**Preliminary Drainage Report
For:
Northwest Corner of Pima Rd. and Dynamite Blvd.
Plan Check Number 2701-09**

Comments on Case drainage report (Cycle #2)
NWC of Pima & Dynamite
(City of Scottsdale Plan #: 5521-09; Previous Plan #: 2701-09)

Stormwater Review By:	
Mohammad Rahman	
Phone 480-312-2563 FAX 480-312-7971	
E-mail mrahman@scottsdaleaz.gov	
Review Cycle	Date
#2	4/9/10

EXHIBIT 5

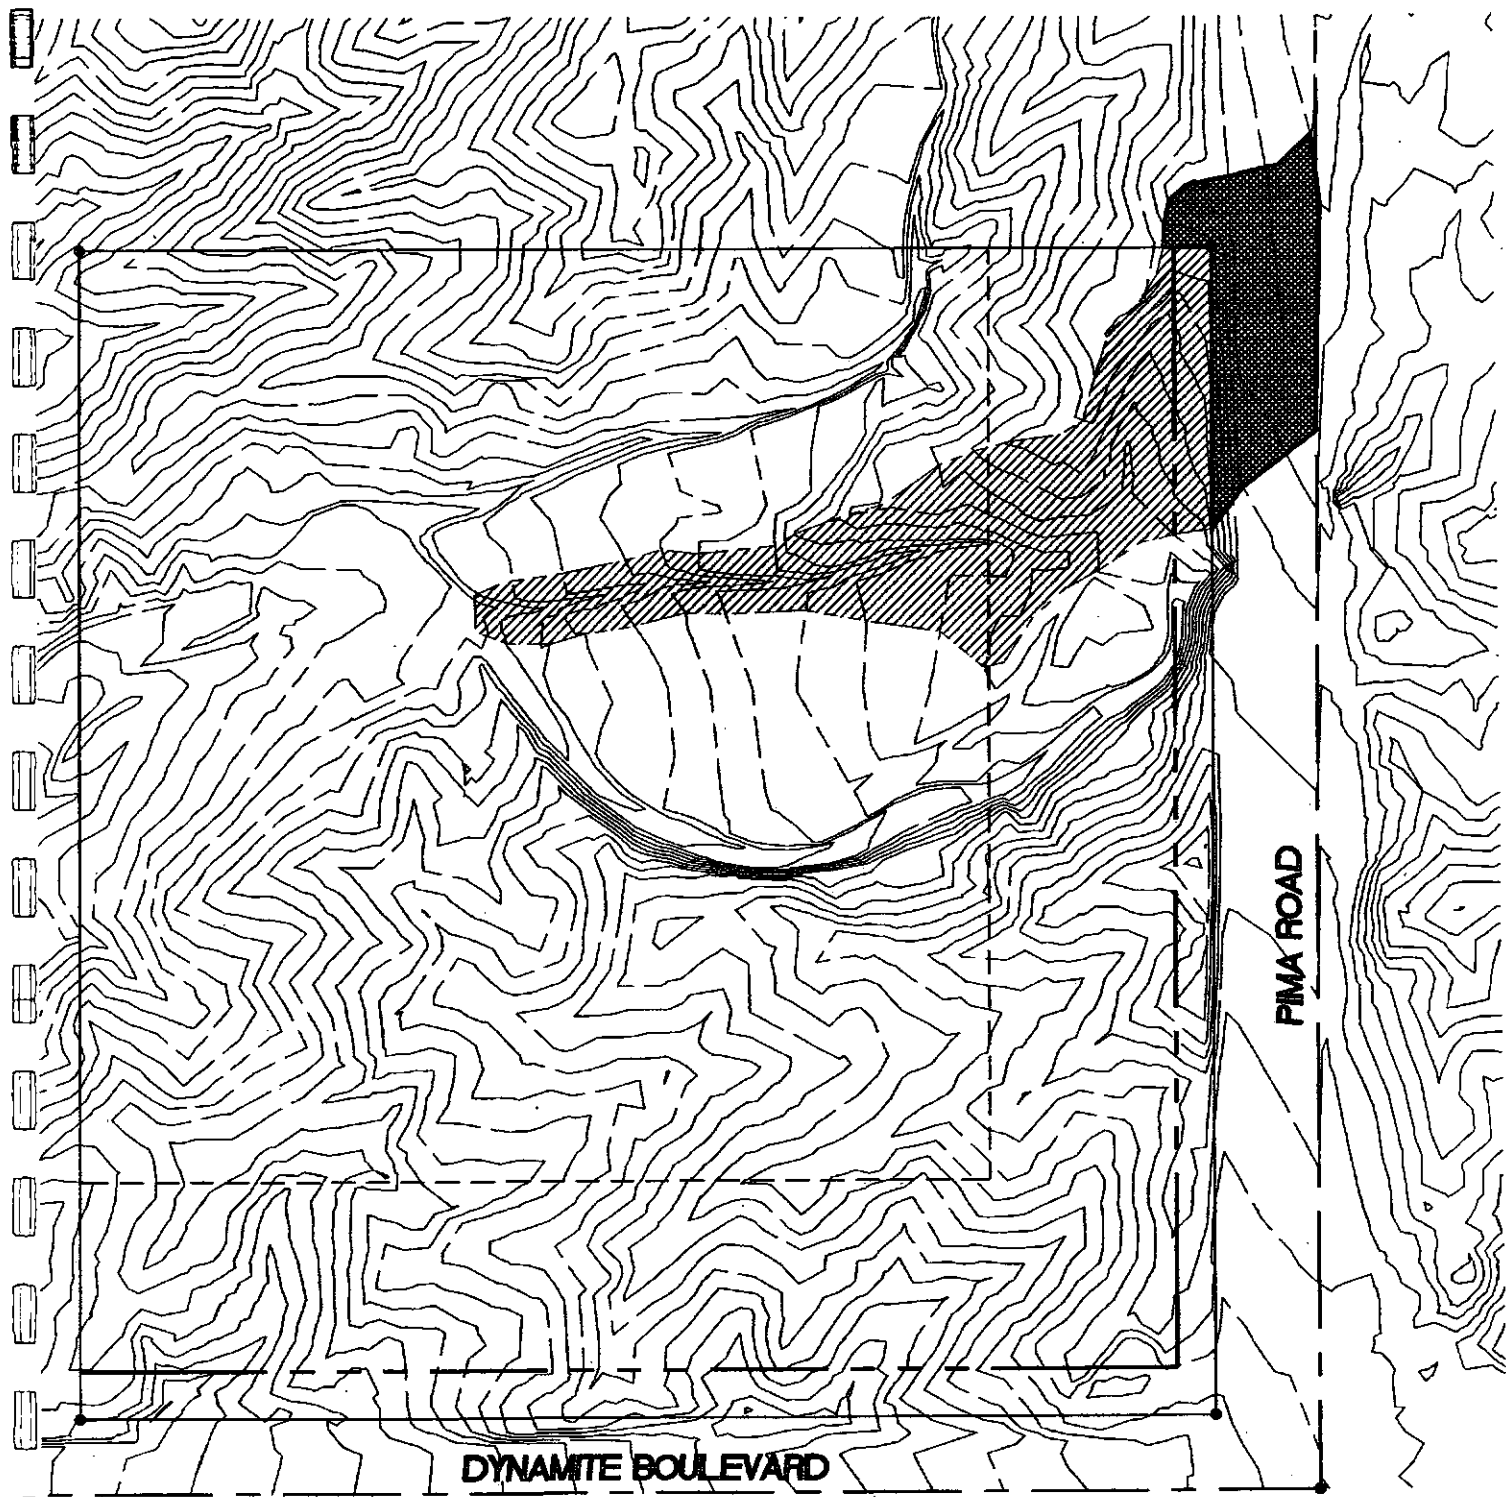
Cycle#2: Addressed. However, please label/mark Wash #6 in Exhibit 5 of the Drainage Report and on the Grading & Drainage Plan.

**Wash # 5 330 cfs Maximum Flow
Worksheet for Trapezoidal Channel**

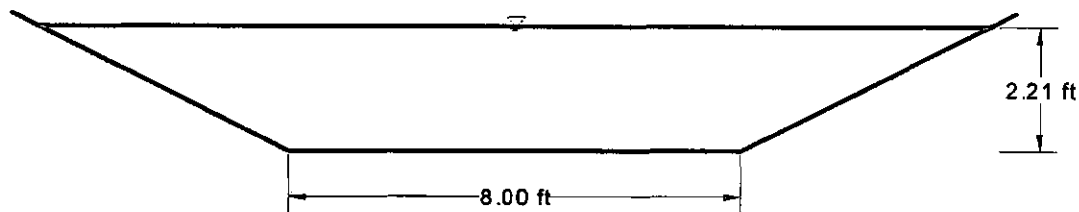
Cycle#2: Please note that FlowMaster calculations using trapezoidal channel for Wash #3 and Wash #5 are not acceptable. Real irregular cross-sections should be cut from the contours and should be used in FlowMaster.

3 - 30" CMP Wash # 3 First Crossing

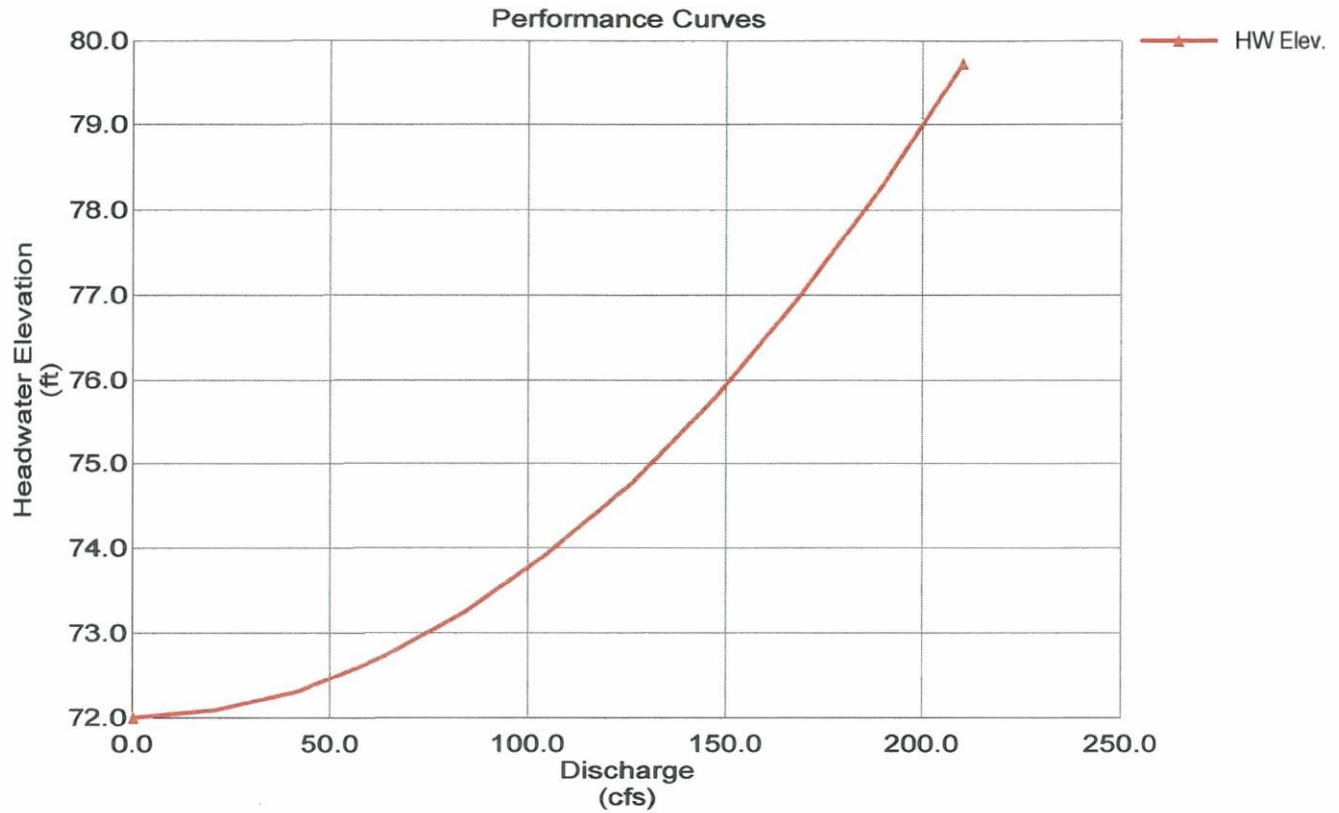
The G&D plan shows 3-36” proposed CMP for Wash #3. However, the Drainage Report shows CulvertMaster calculation for 3-30” CMP. Please also note that the computed headwater elevation is 74 ft. and long before this elevation is reached, the floodwater will travel from east to west by overtopping the 72 ft. contour and will end up somewhere else. Therefore the capacity of this culvert is not sufficient. The tailwater elevation used in the CulvertMaster calculation should be based on the 100-yr water surface elevation in the wash immediate d/s of the proposed pipe culvert based on real irregular cross-section (not trapezoidal channel section). Please refer to the marked G&D plan for reference.
